## **Application 2220163-RMACOM - Response to Request for Further Information dated 18 October 2022**

- 1.3 On 18 October 2022, Far North District Council (**Council**) made a request for further information in relation the Application (**Request**).
- 1.4 We have summarised each item in the request in italics, and provide a response to each item in the Request below.

TITLE  
**SCHEME PLAN**  
 BEING A SUBDIVISION OF  
 PT LOT 1 DP 67692 & LOT 6 DP 417562  
 STAGES 3 & 4

Figure 5 – Northland Regionwide Flood Models

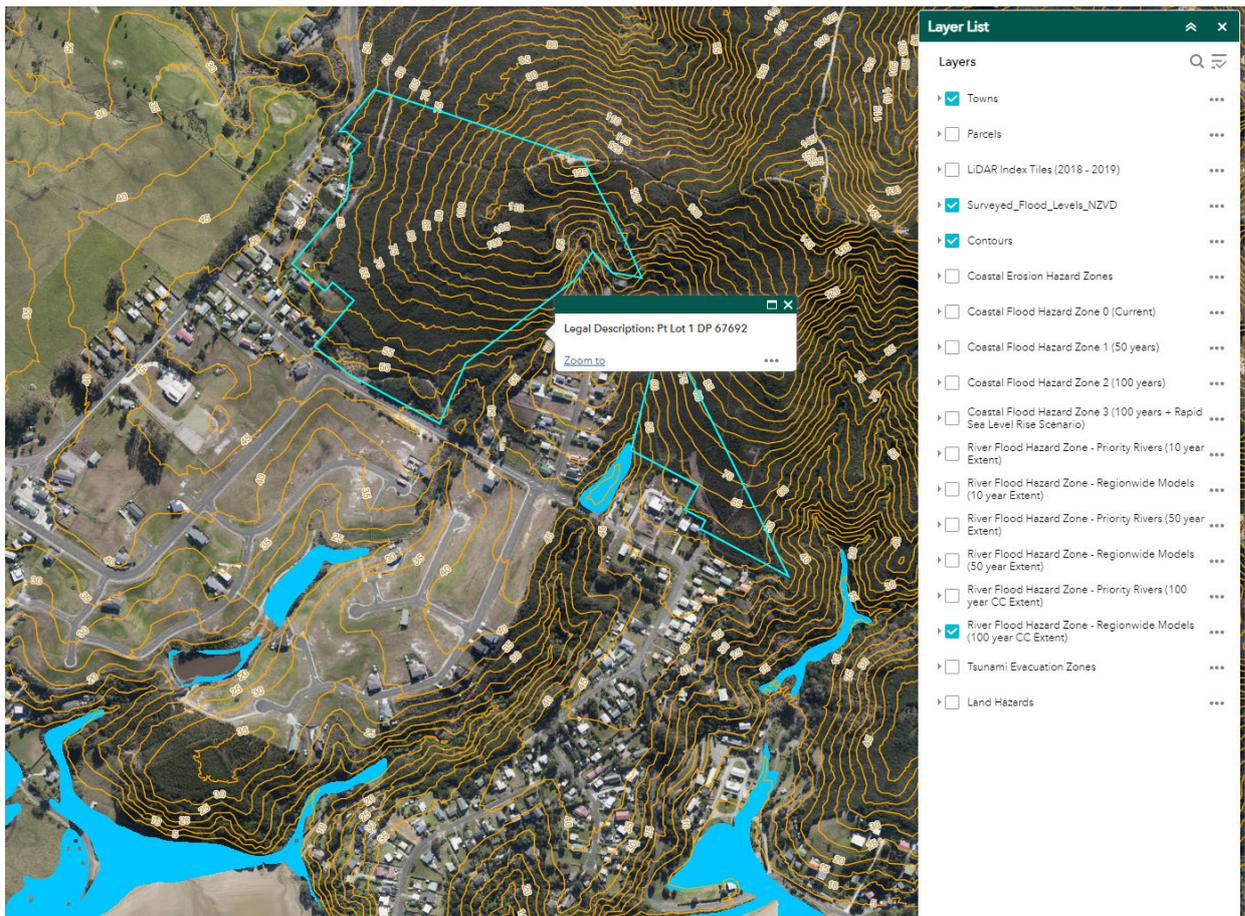
12.1 *Please supply a flood report from an appropriately qualified engineer detailing the risk of land in the subdivision to flooding and if so any appropriate recommendations.*

- 15.3 The design is proposed to follow Table 4.1 Design Summary of the 2022 EES, which we have copied above.
- 15.4 There is no need to assess downstream infrastructure due to this conservative approach. The Site was zoned residential at the time that the downstream stormwater works were constructed and the existing stormwater detention dams within the gullies also account for stormwater discharges from the development of the Site. In addition, stormwater is to be attenuated on Site as above, reducing pressure on the downstream system.

- 15.5 Coastal inundation flooding downstream will not be affected by the development, as stormwater is confined to the gullies.
- 15.6 The aerial imagery shows that there is sufficient capacity in the steep undrained gullies to convey the stormwater. The image attached below shows the contours where there is often 5m of freeboard before there will be any downstream flooding concerns.

**Appendix B – Revised Scheme Plans**

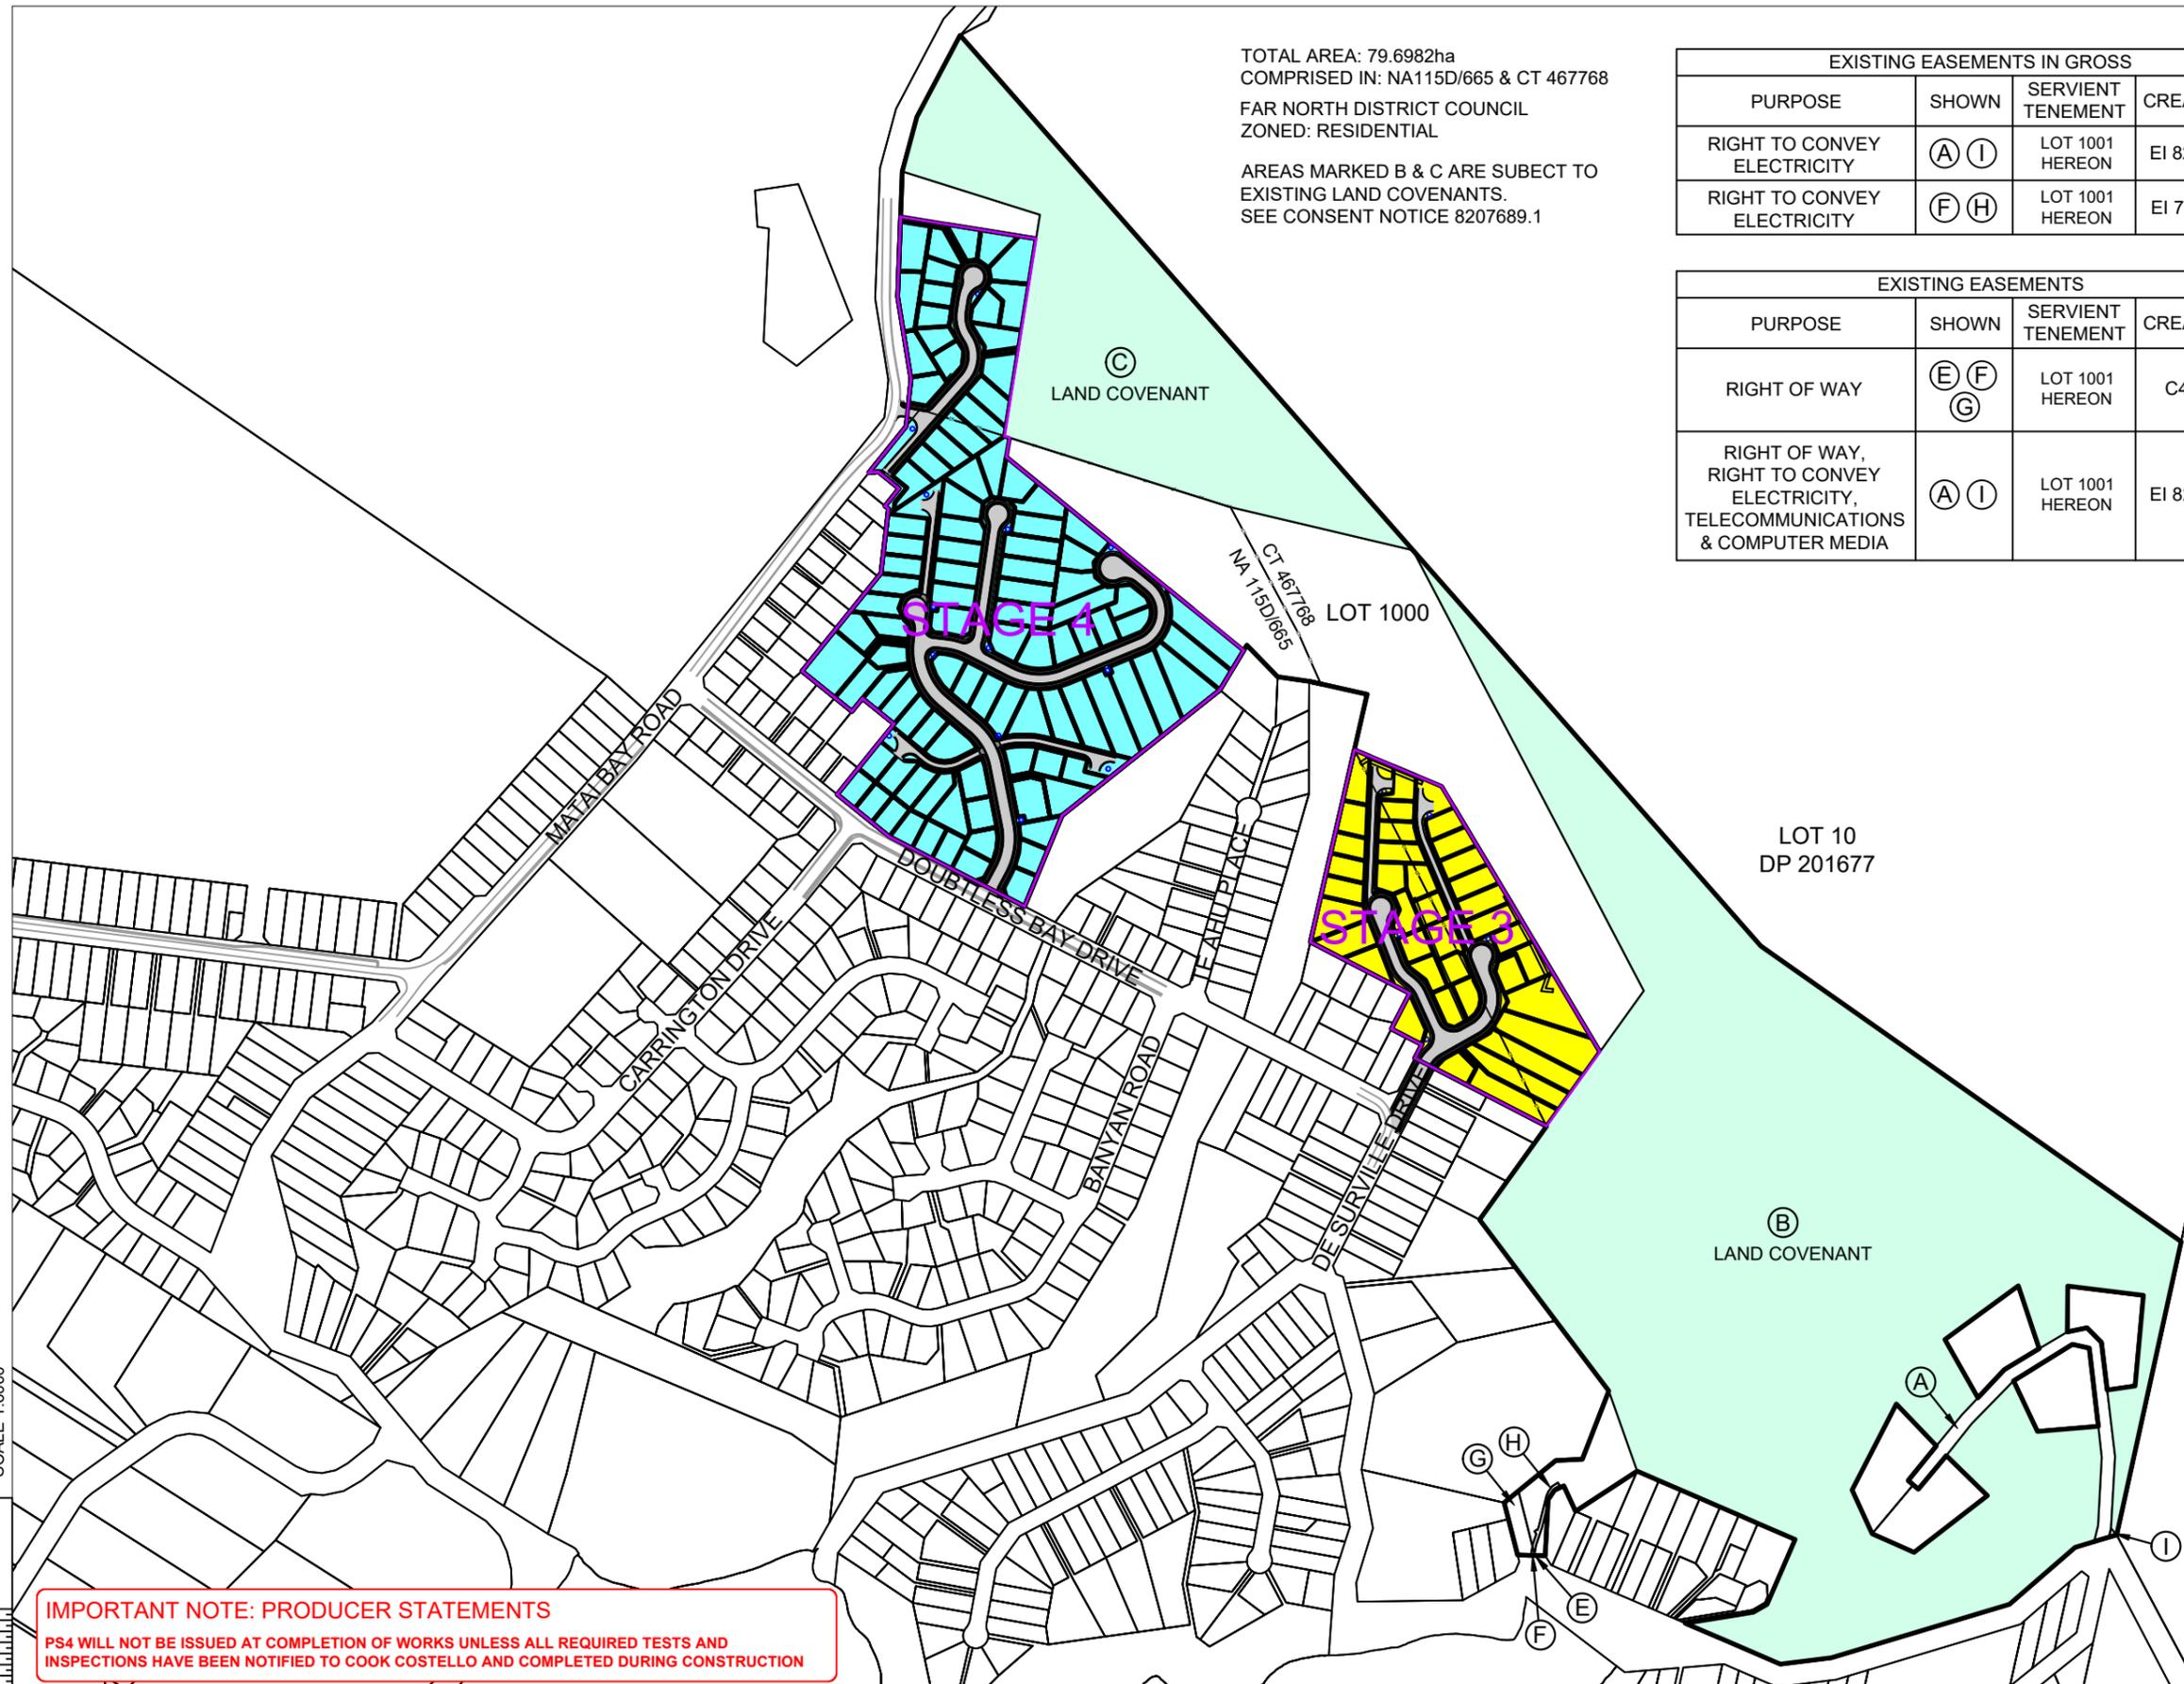
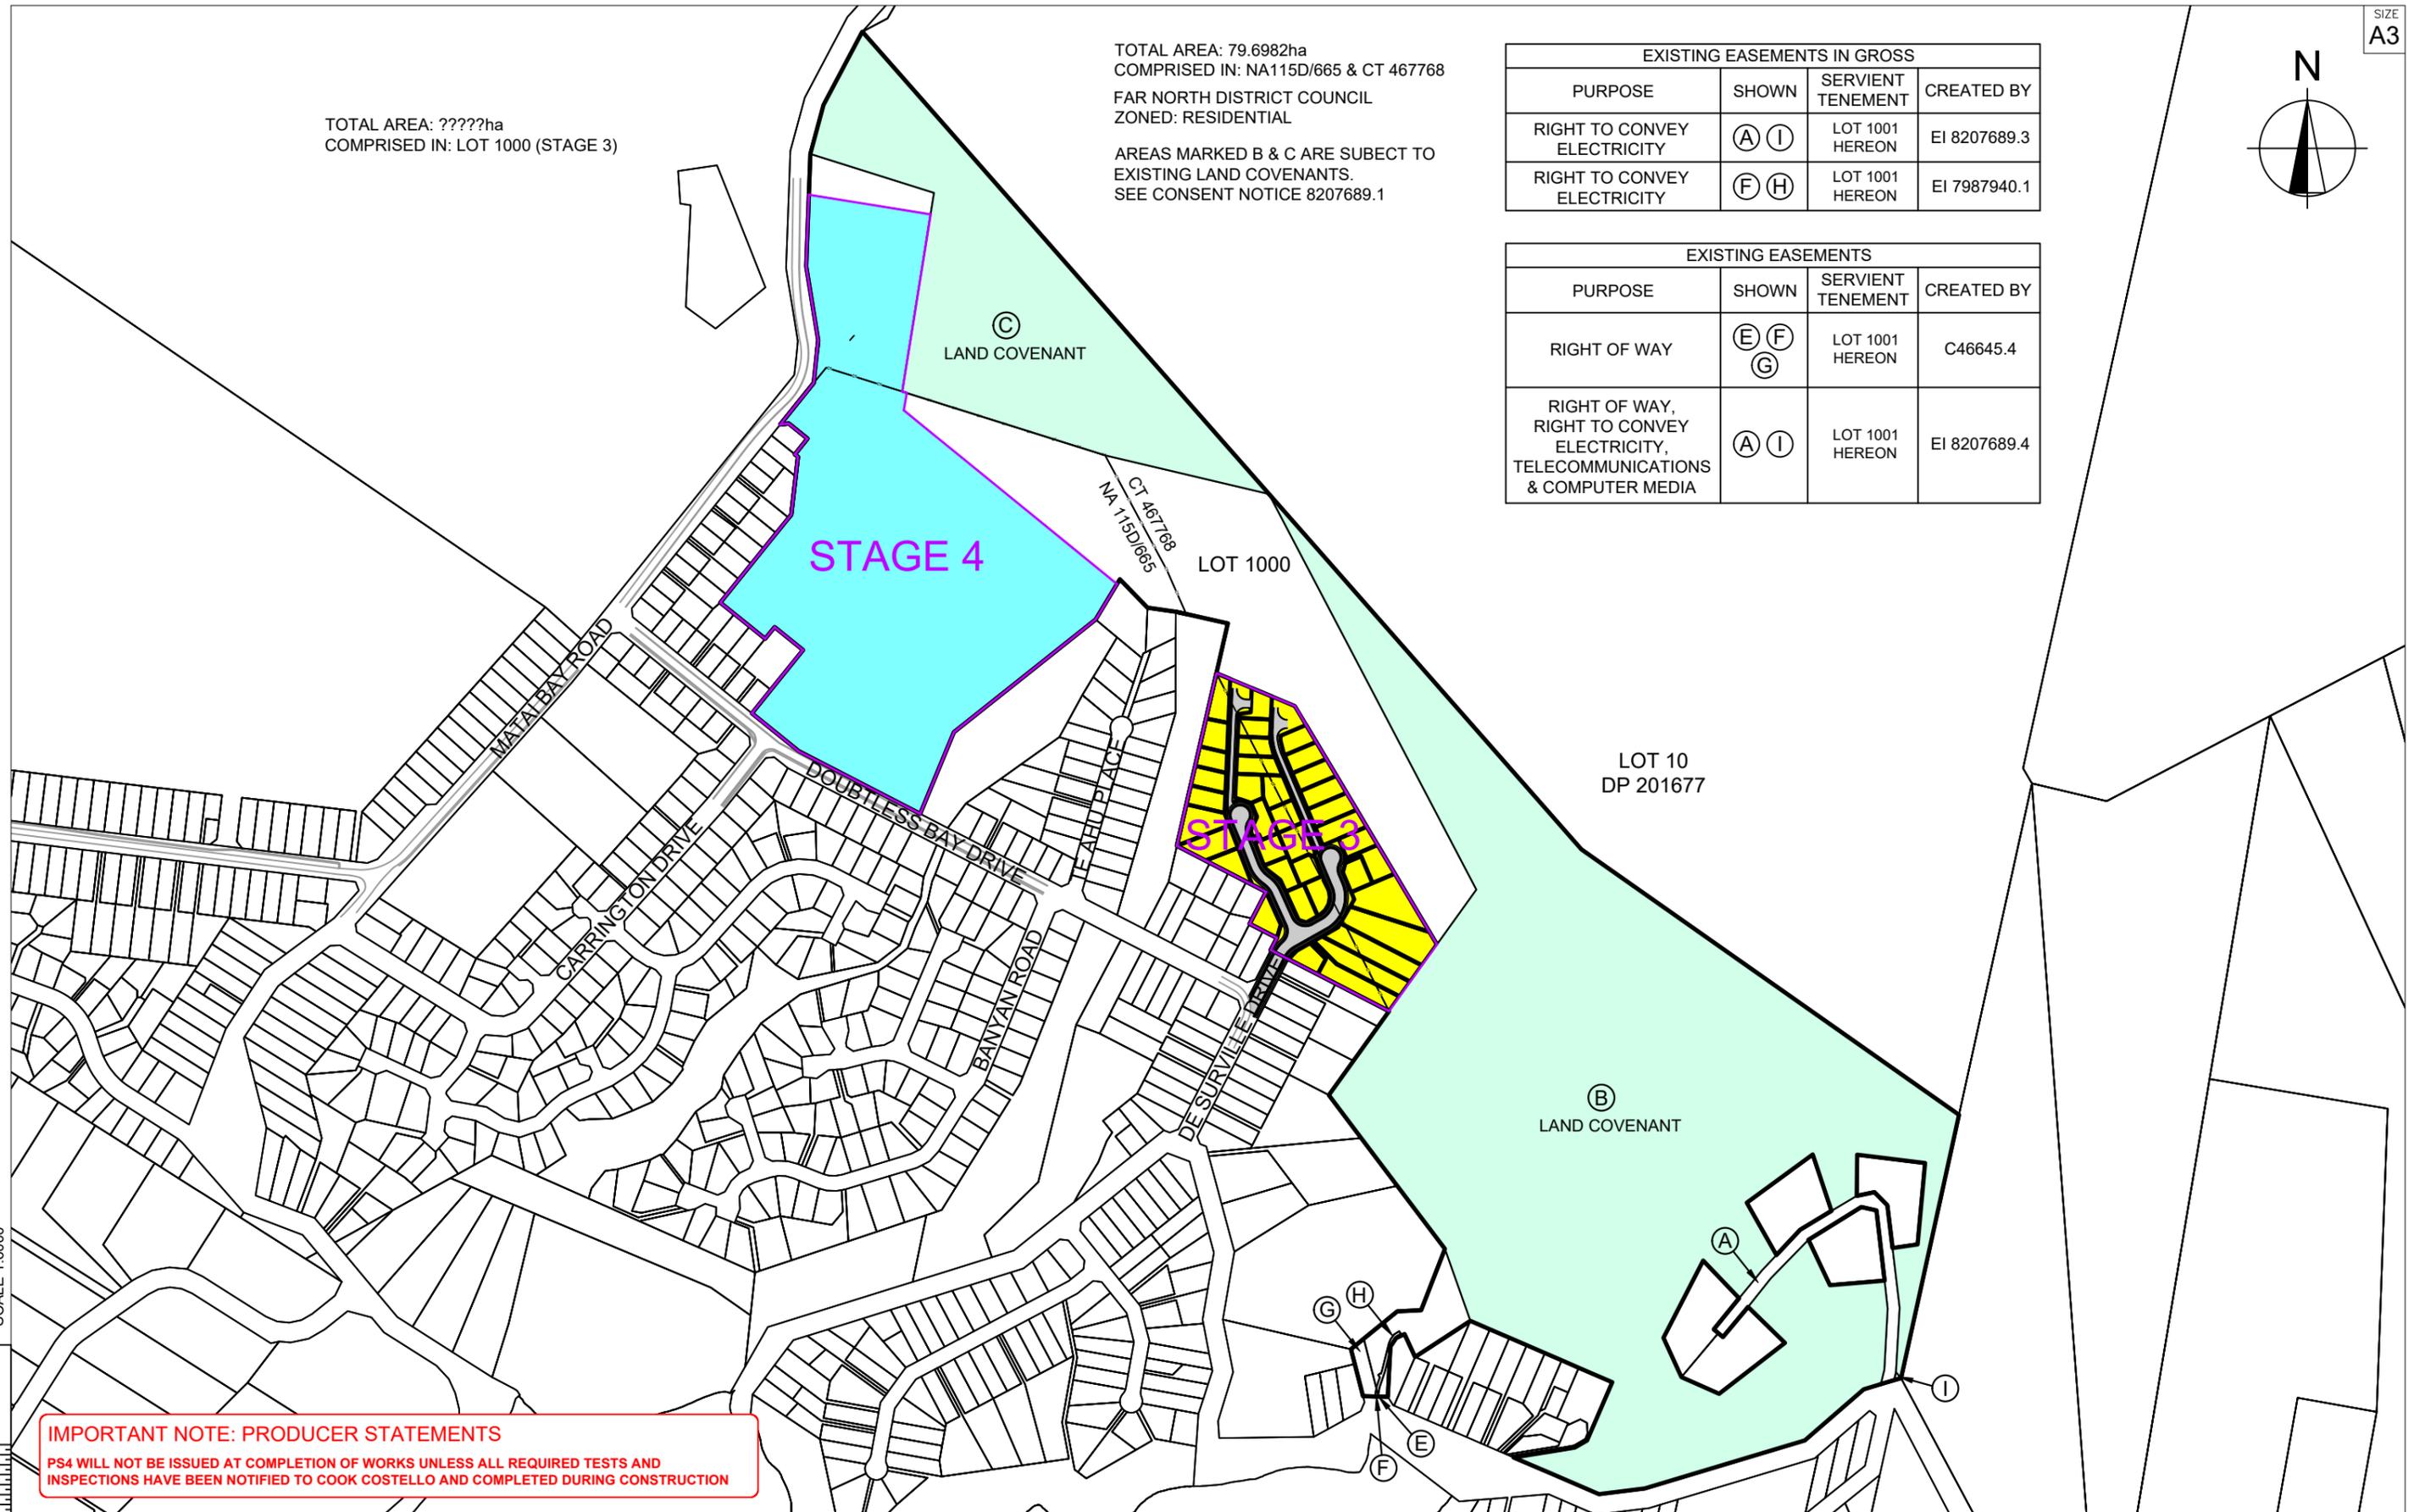
- 6.1 *Documentation supplied (Draft 2021 Scheme Plan Von Sturmers) for stages 3 & 4 show that Lot sizes are less than the required 600m<sup>2</sup> minimum size for Residential zoned sewerred sites (at a glance Lots 57, 96, 97, 99, 100 etc). The subdivision does not appear to meet zone standards as a controlled activity (13.7.2.1(v)).*

- 6.2 *Please confirm whether management plan subdivision is intended, and if so supply the management plan. Please supply all information necessary to complete the required assessment under section 13.10 of the Operative FNDP.*

- 6.3 Attached as **Appendix B** are revised scheme plans which identify that all lot sizes are 600m<sup>2</sup> or greater and therefore comply with standards of a controlled activity.

- 6.4 As a result of the revisions to the scheme plans, there have been amendments to the boundaries of the allotments. The outcome is that there is a minor decrease in the total number of lots. The revised plans provide for 38 lots in stage 3 and 100 lots in stage 4, which is two less lots than the scheme plans filed with the Application, which provided for 36 lots in stage 3 and 104 lots in stage 4.

- 6.5 We note the revised scheme plans show where some roads have been narrowed and are now proposed to be jointly owned access lots to minimise earthworks and improve the development layout.

- 16.4 *What is considered the optimum size for lots in stage 4?*
- 16.5 The revised scheme plan attached to this letter shows the appropriate size for lots in stage 4 of the proposed subdivision. The proposed lots all have an area greater than 600m<sup>2</sup>, and allow for a 14m x 14m square with a 3m setback from the road boundary and 1.5m side yards.
